LOCAL HISTORIC DISTRICT: Wilmore

PROPERTY ADDRESS: 304 Westwood Avenue

SUMMARY OF REQUEST: Addition

HDCADMRM 2019-00287

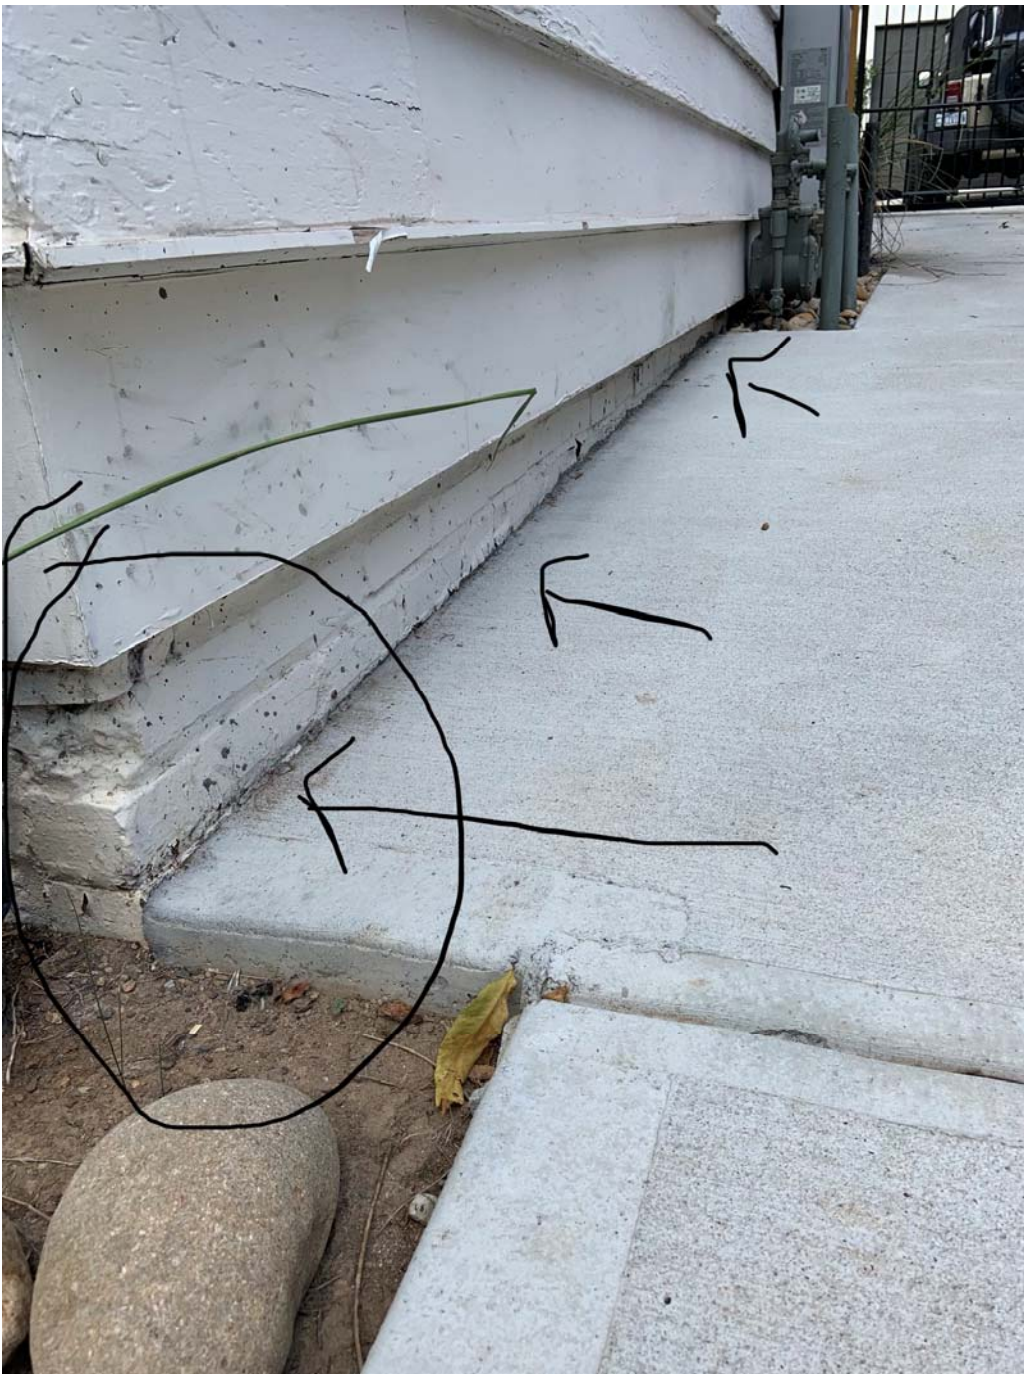
Cynthia,
My conversion with my concrete contractor was that if we jack hammer this out it could compromise the brick crawl space foundation. It could crack, cave it inward or pull it out if it adhered to the new concrete and there is no way to know if it will or not. Could jeopardize foundational structure of home on that side.
I will continue to try and get this in writing
Thanks
